LAND WEST OF IMBERHORNE LANE | EAST GRINSTEAD

SUMMARY OF FURTHER AMENDMENTS | JULY 2026

THE FOLLOWING DOCUMENT SETS OUT THE AMENDMENTS TO THE LAYOUT AND THE REQUESTED ARCHITECTURAL CHANGES THROUGHOUT THE APPLICATION PROCESS.

PROPOSED | PLANNING LAYOUT - 1:1000

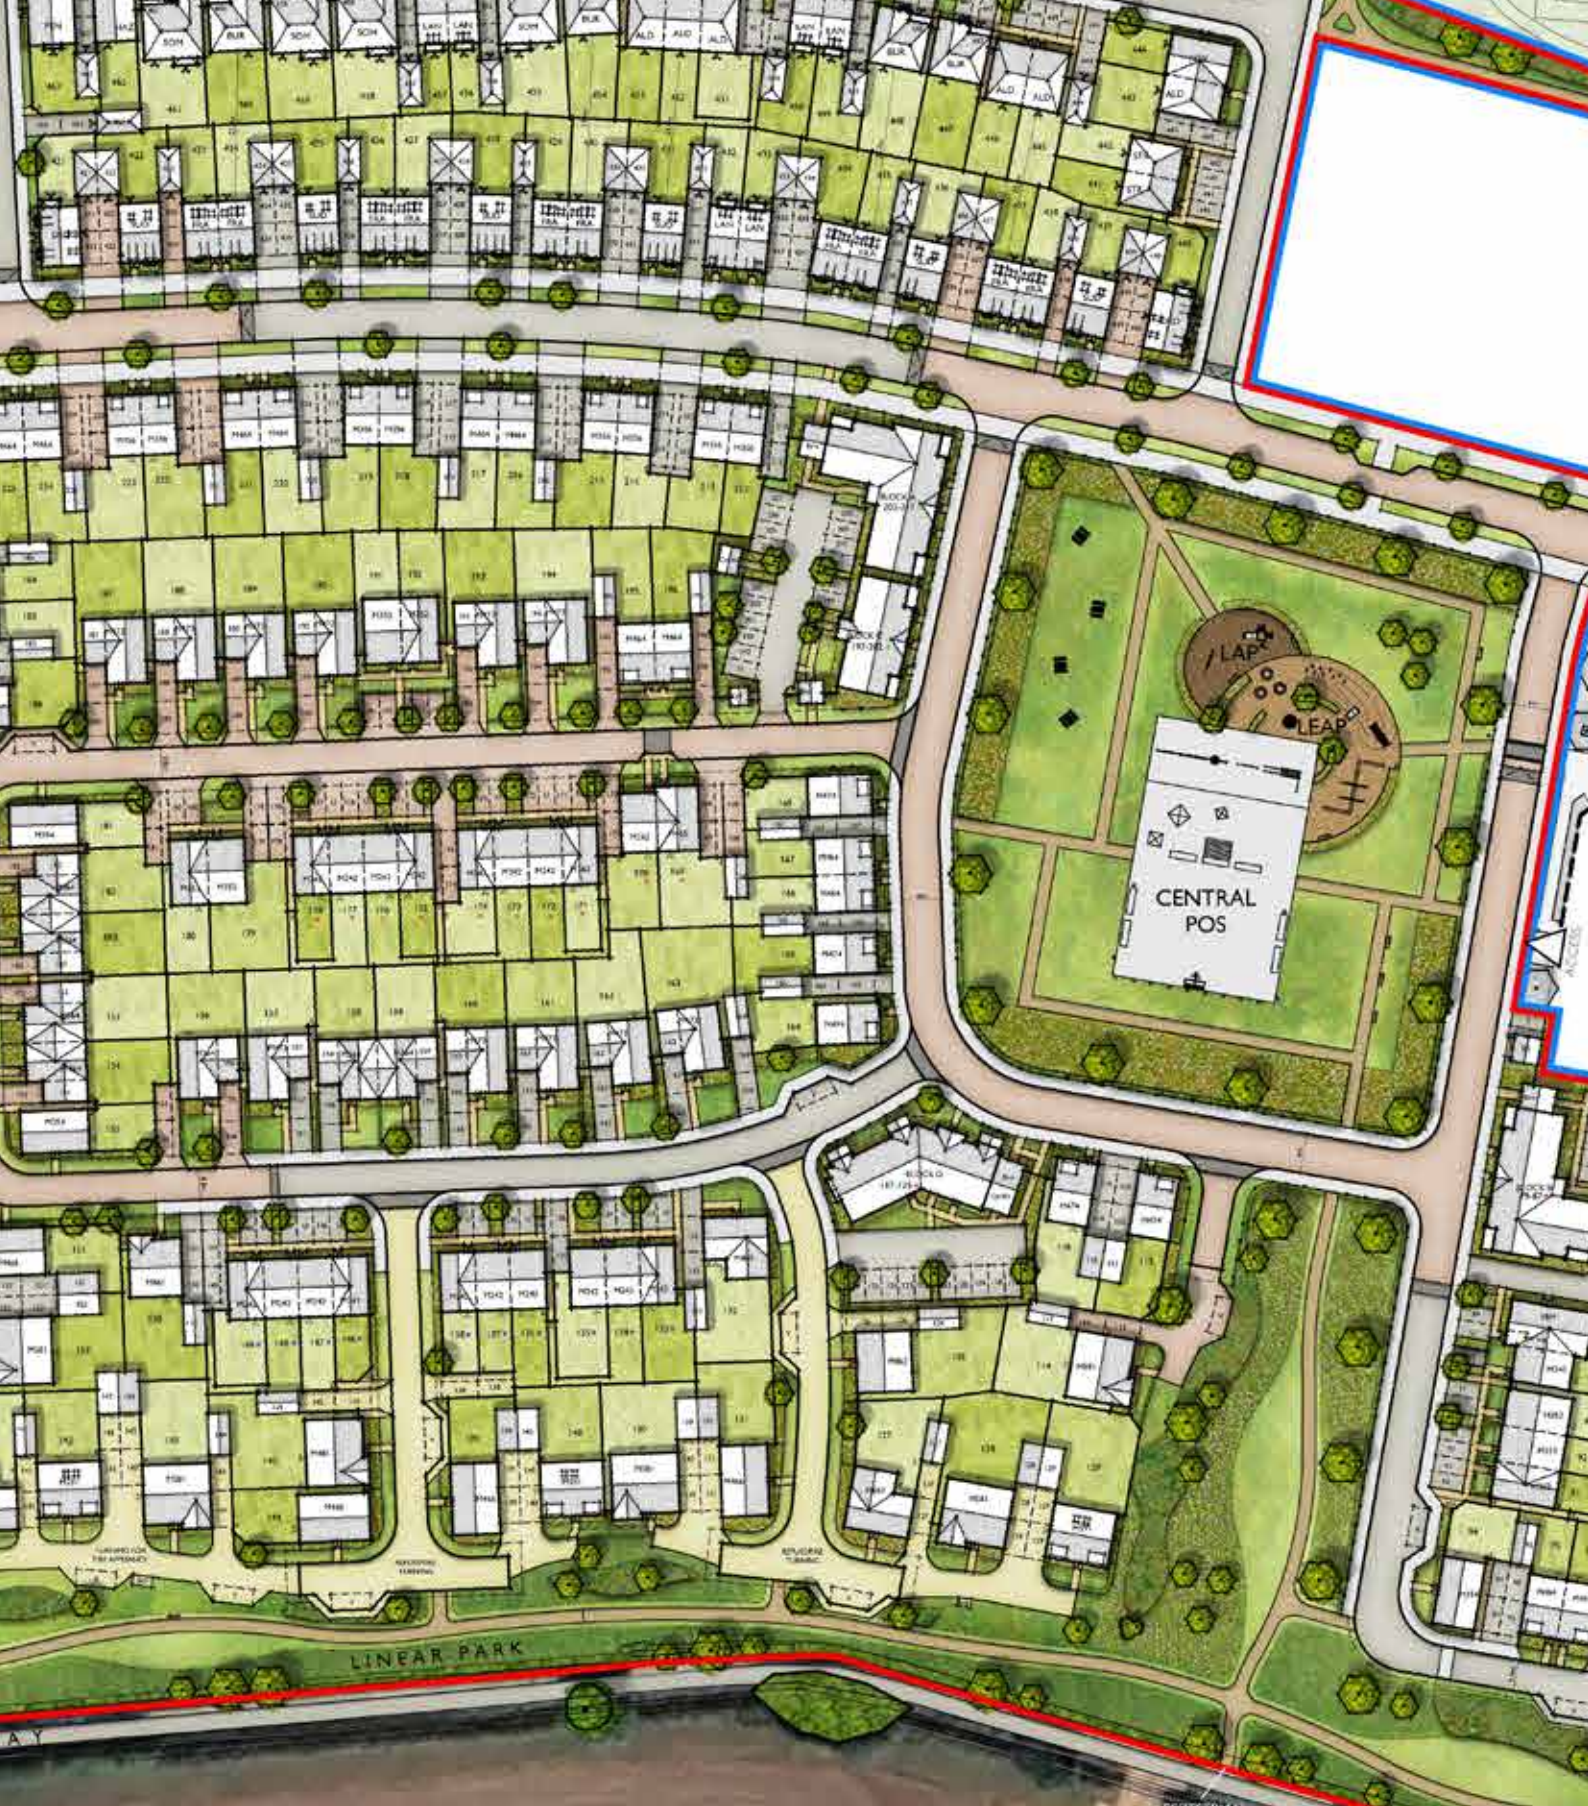
- ① 3B5P Dwelling widened to all for the internal changes to the M4(3) dwelling based on Housing Officer comments with amendment to the drive way;
- ② Changing the bin store location to meet Premier concern of carry distances for occupant. No change to wheelie bins operative distances;
- ③ Change to the M4(3) 1 BF dwellings to meet Housing Officer comments and accessible requirements. Building slightly larger 350mm. Change to ground floor window
- ④ Change to IBM M4(3) accessible requirements: entrance, bathroom and kitchen and increased in size 675mm
- ⑤ Change to all ground floor balconies are proposed as patios but visually look the same as before.
- ⑥ Path link to care home
- ⑦ Footpath added to edge of carriageway
- ⑧ Additional fencing has been added to SuDS features as requested by the LPA
